Subject: **Revised Seismic Models for the ESBWR Control Building (CB)**

**Revised Seismic Models for the  
ESBWR Control Building (CB)**

Shimizu Engineering Report					
Project	General Electric Company ESBWR Project		Shimizu Document No.	SER-ESB-024	
Title	Revised Control Building Stick Model		Rev.	1	
			Issued Date	6/22/06	
			Revised Date	7/26/06	
<p>NOTE:</p> <p>This document provides the revised Control Building (CB) stick model in response to NRC's Audit comment on RAI 3.7-36.</p> <p>Rev. 0 of this report was originally issued by Reference 1.</p> <p>The following portions were revised in this revision.</p> <ol style="list-style-type: none"> <li>1) Floor oscillators are added to consider the high frequency range up to 50 Hz.</li> <li>2) Appendix C, which provides clarifications on Dr. Constantino's questions in his 7/16 letter to the NRC, was added.</li> </ol> <p>Reference: 1. SH-ESB-2006-0068, dated June 22, 2006</p>					
1	7/26/06	Revision of seismic model. Addition of Appendix C.	Y.O.	M.T	S.O
0	6/22/06	Initial Issue	Y.O.	M.T	S.O

**Appendix C Clarifications on Dr. Constantino's questions in his 7/16 letter to the NRC**

Figure B-1 Control Building EW-section

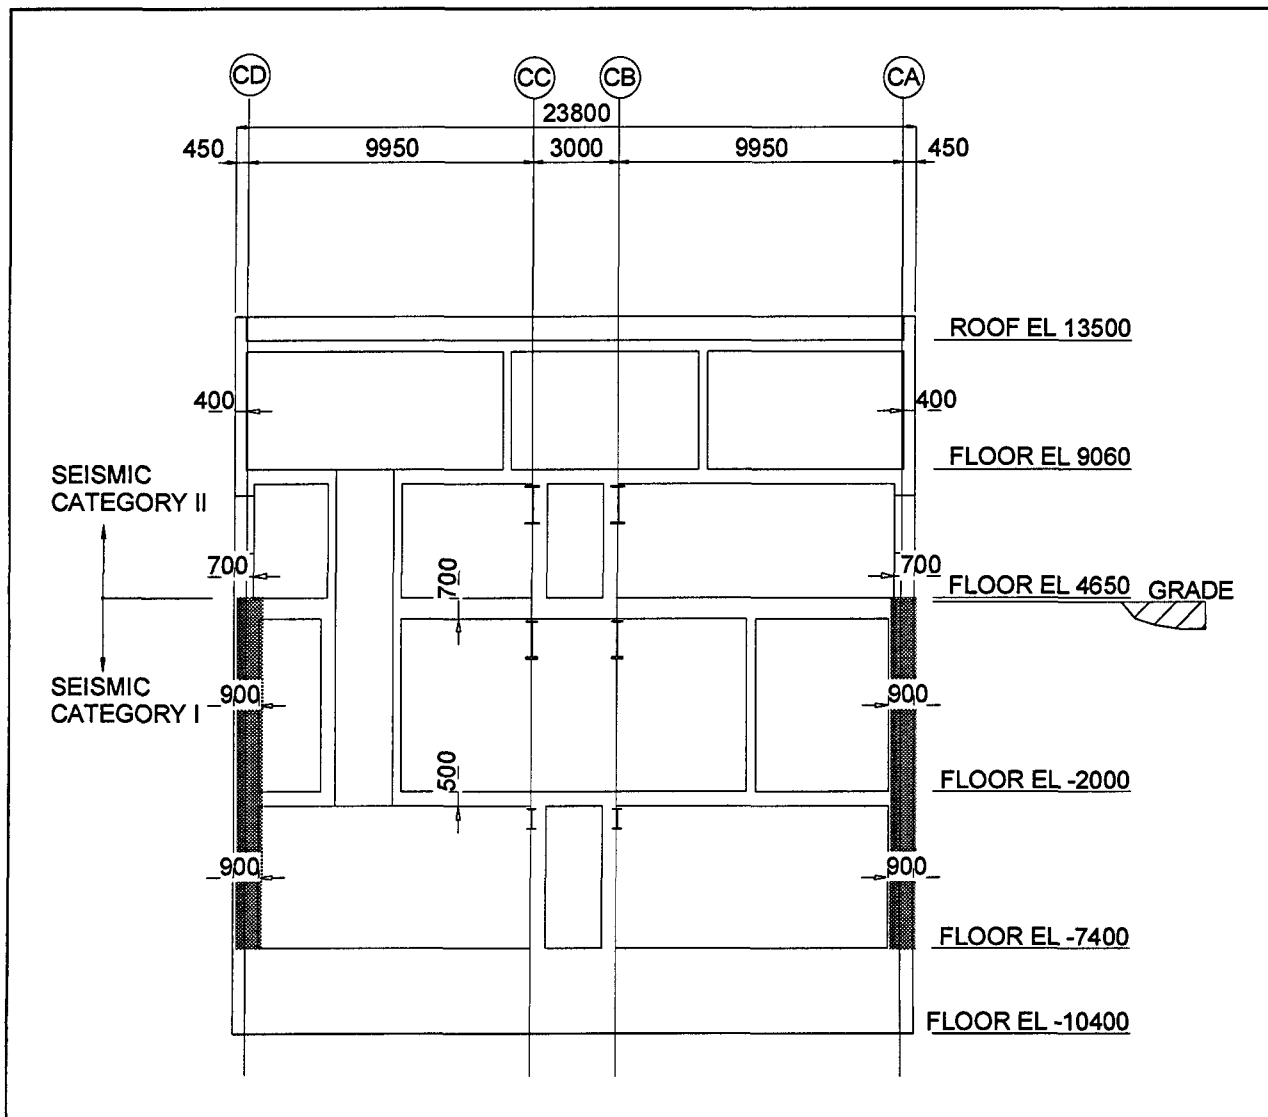
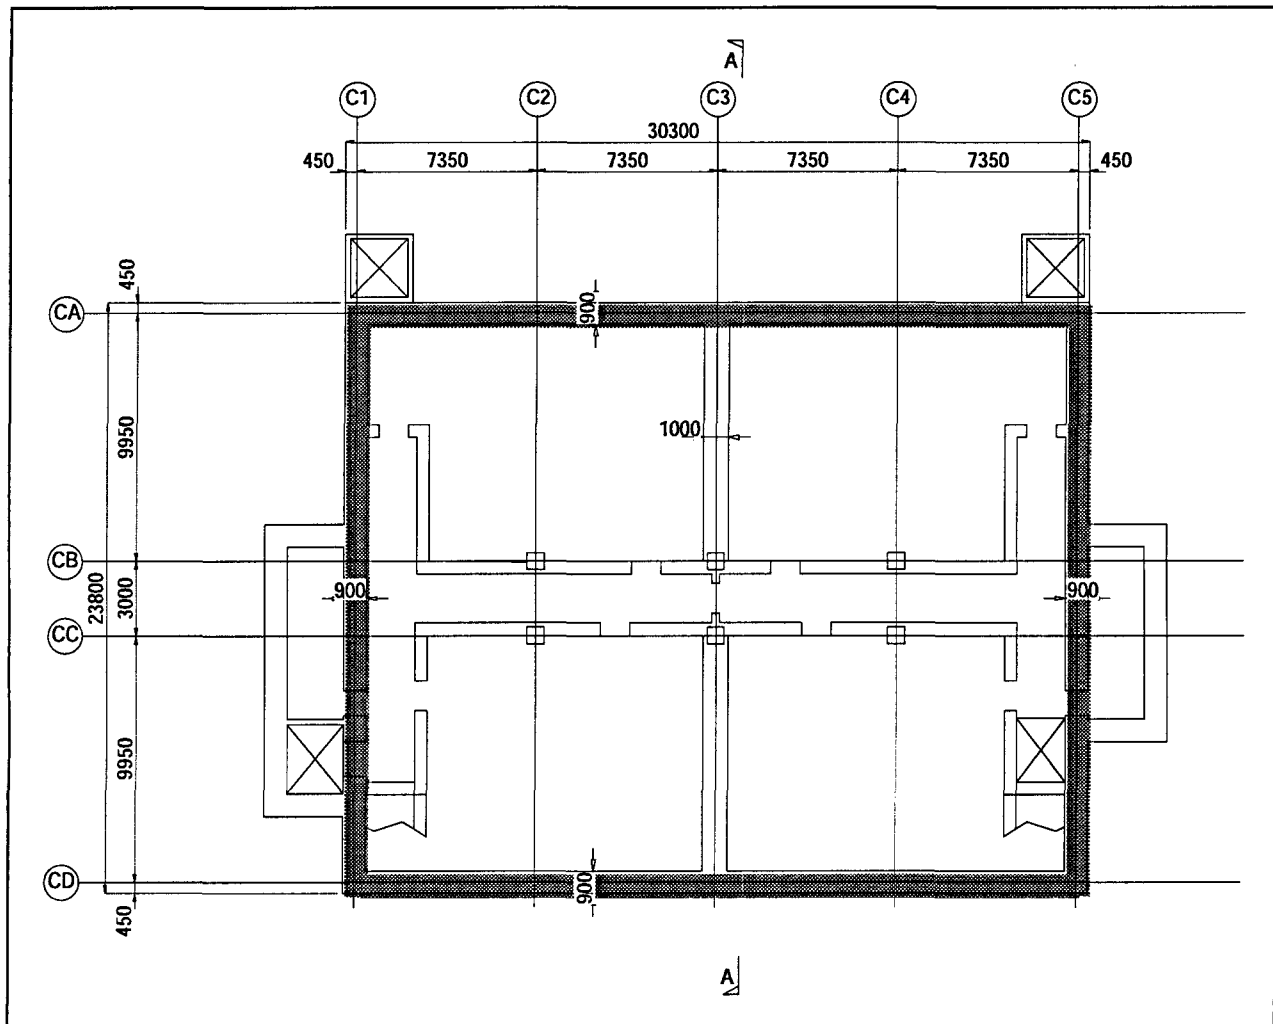
The geometric properties of the SASSI house file match with the data given in Table B-1 of the report. Beams 4 and 9 do not exist in the report, and based on the beams' elevations their properties do not correspond to those given in the report.

- Why do the geometric properties for beams 4 and 9 match the geometric properties for the beam above, rather than the beam below, as would match the properties given in the report?

To facilitate SASSI modeling an additional node at the grade level (EL. 4.5) is added to the stick. As a result, the beam element representing the walls from EL 4.65 to EL 1.325 is split into two parts in SASSI, beams 4 and 9 from EL 4.65 to 4.5 and beams 5 and 10 from EL 4.5 to 1.325. Since they all represent the same walls, the properties for beams 4 and 9 are the same as those for beams 5 and 10 below.
